UNITED STATES PATENT AND TRADEMARK OFFICE

APPLICATION NO.	FILING DATE	FIRST NAMED INVENTOR	ATTORNEY DOCKET NO.	CONFIRMATION NO.
10/689,706	10/22/2003	Jung Hyun Lee	2336-214	4635

Office Action Summary

DETAILED ACTION

Regarding claim 1, JP '885 discloses a MEMS (Micro Electro Mechanical System) variable optical attenuator (e.g., see Figure 4) comprising:

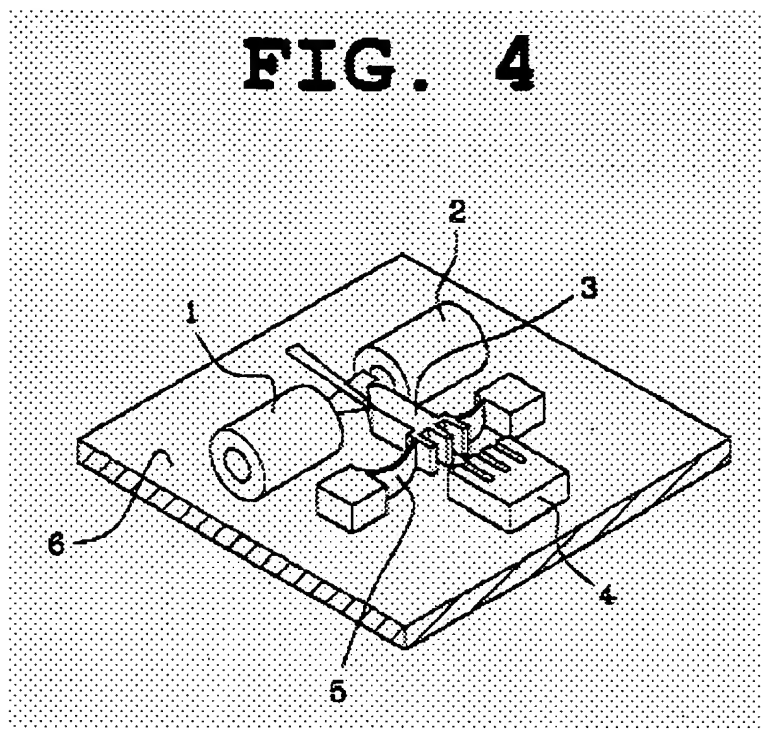
- a substrate 6 having a flat upper surface;

- optical transmitting and receiving terminals (1, 2) arranged on the upper surface of the substrate so that optical axes of the terminals coincide with each other;

- a movable optical shutter 3 arranged at a location such that it attenuates the maximum amount of light transmitted between the optical transmitting and receiving terminals;

- a micro actuator 4 arranged on the substrate for moving the movable optical waveguide;

- and a voltage supply unit (inherent, not shown) for supplying driving voltage to the micro actuator 4 , wherein the micro actuator 4 moves the movable optical shutter so that the light attenuation amount is decreased in accordance with the increase in the driving voltage applied by the voltage supply unit. See the '845 patent at column 5, line 3 to column 6, line 5. Figure 4 is reproduced below.

Regarding claim 6, the micro actuator 4 includes: a movable electrode unit arranged on the substrate and provided with a first comb unit moving in the direction perpendicular to the optical axes; and a driving electrode unit fixed to the substrate and provided with a second comb unit interdigitated with the first comb unit as seen in Figure 4.

Regarding claim 7, compare Figure 4 of JP '885 with Figure 4a of the application drawings.
